PLAN REVIEW SHEET

Petition #: RZP 2023-015

Address: 2501 Wilkinson Blvd.

Request: TOD-CC

Image 1

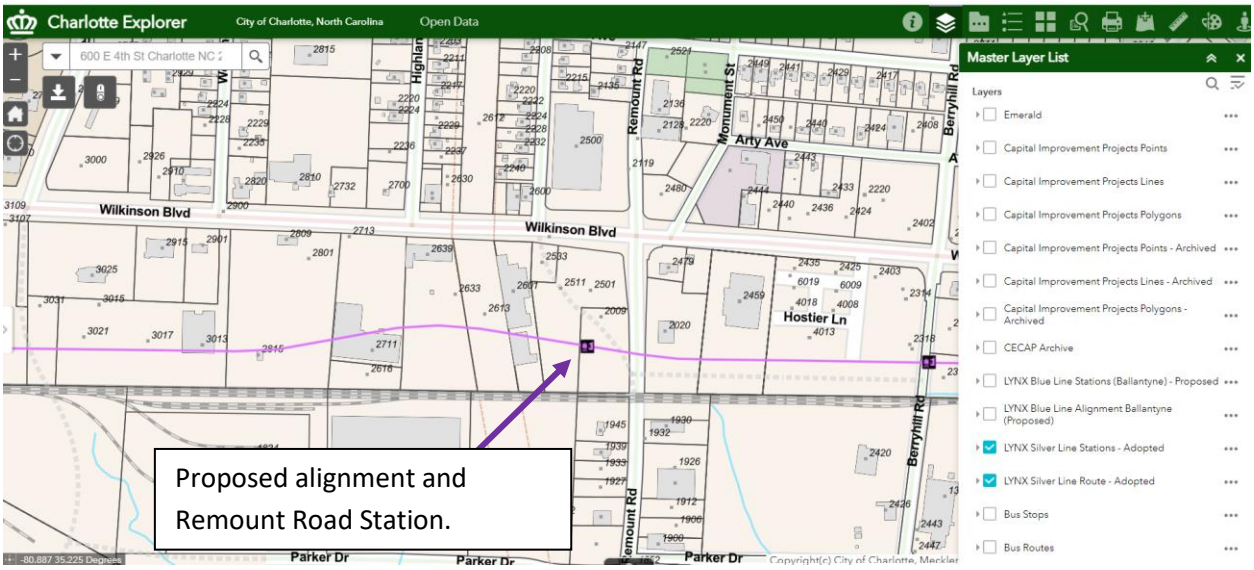
The site is located at the proposed LYNX Silver Line light rail transit corridor and Remount Road station. The minimum required right of way for the light rail corridor is 70 feet (35 feet measured from the centerline of the tracks). However, additional area will be needed for the corridor and the station platform. CATS is requesting a conditional rezoning petition to include the reservation of the light rail corridor and station area as shown on image 1.
